January 4, 2002

Edwin I. Hatch Nuclear Plant - Unit 1
Request to Revise Technical Specifications:
Safety Limit Minimum Critical Power Ratios (SLMCPR)

Page Change Instructions

Figure 1
Reference Core Loading Pattern – Cycle 20

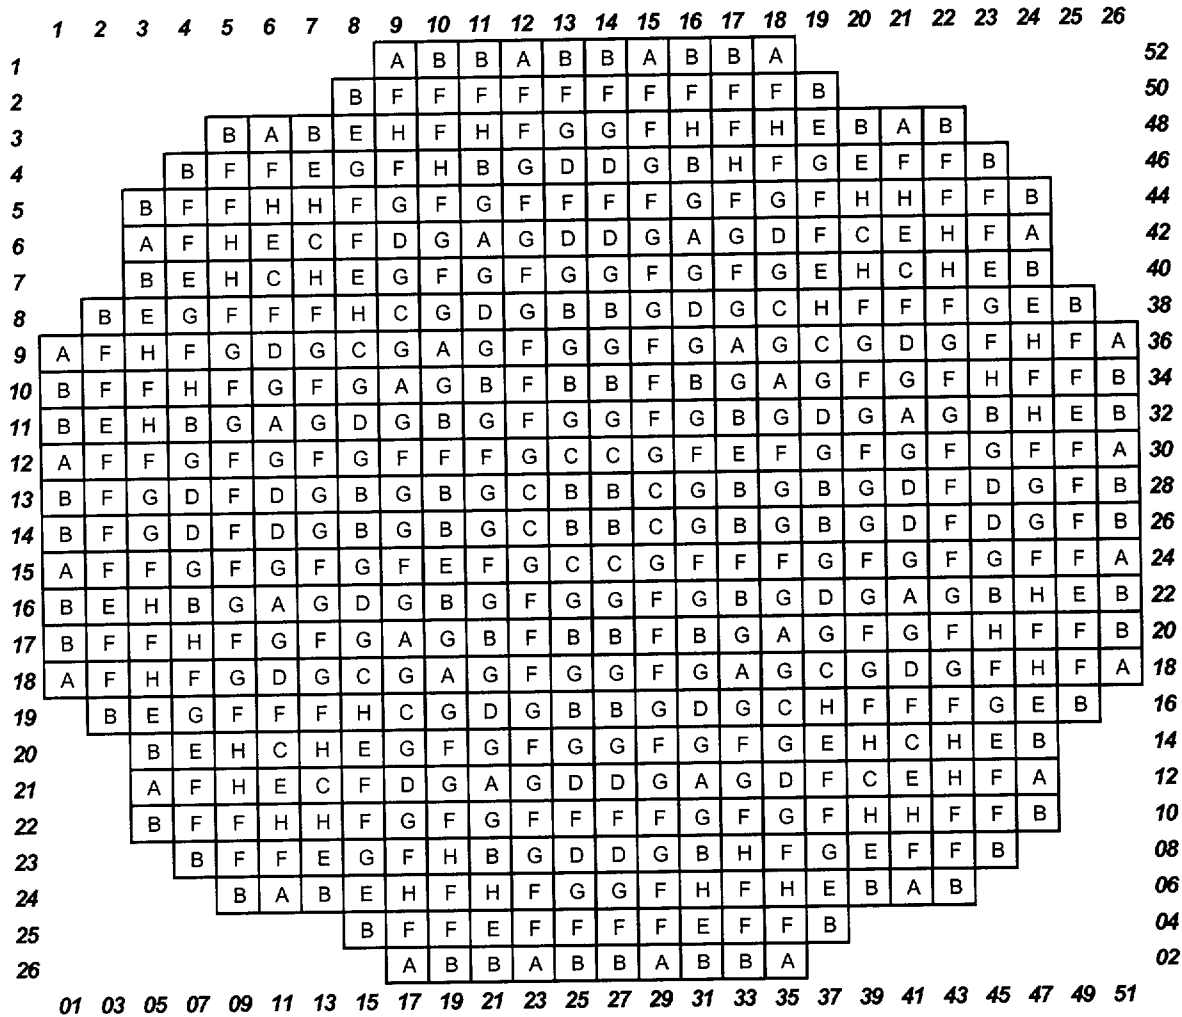
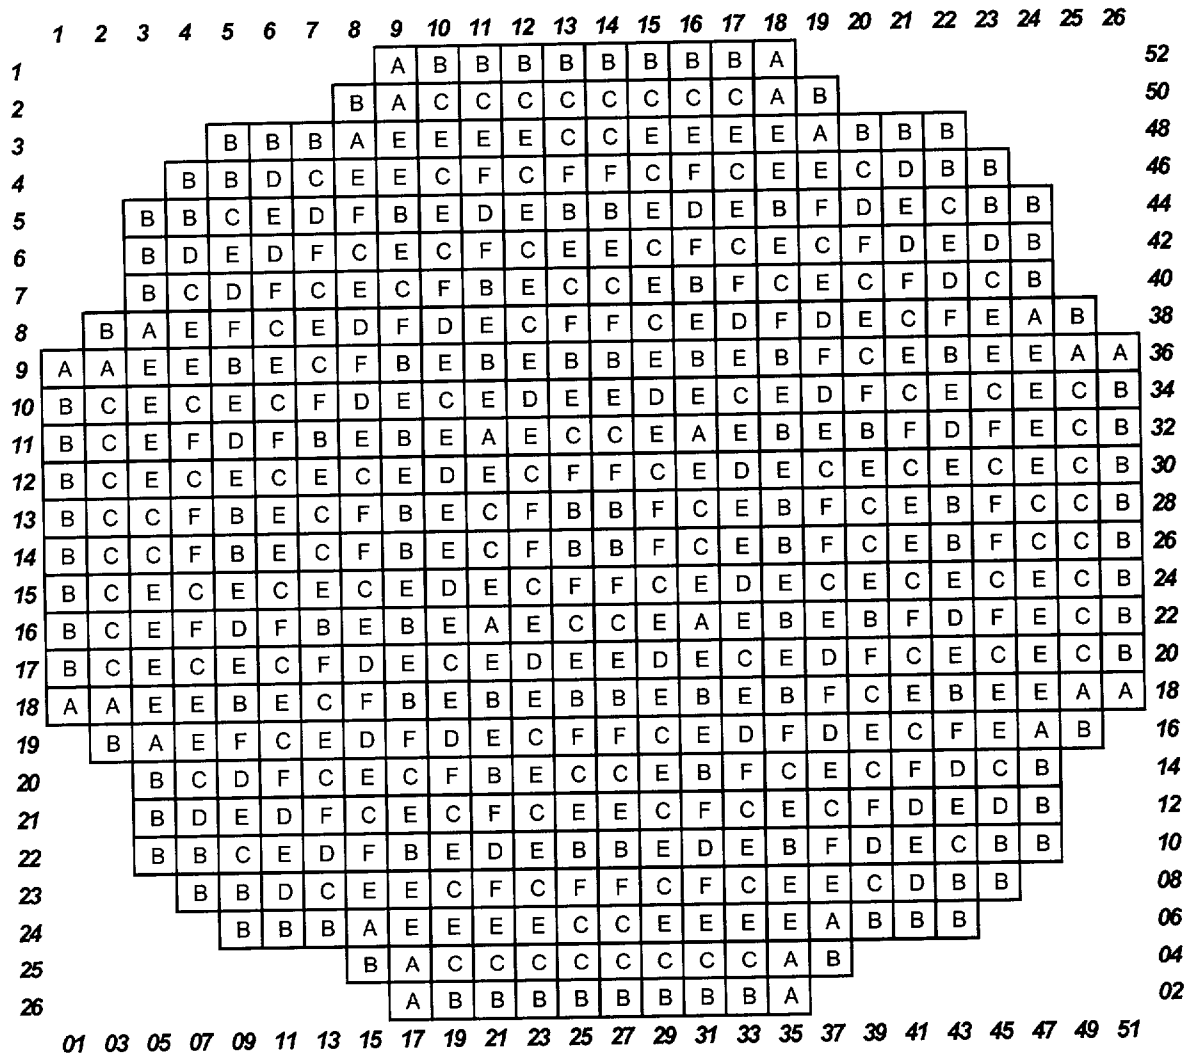
The core loading information for Hatch Unit 1 Cycles 20 and 21 is provided in Figures 1 and 2, respectively. The impact of the fuel loading pattern differences on the calculated SLMCPR is correlated to the values of [[]].
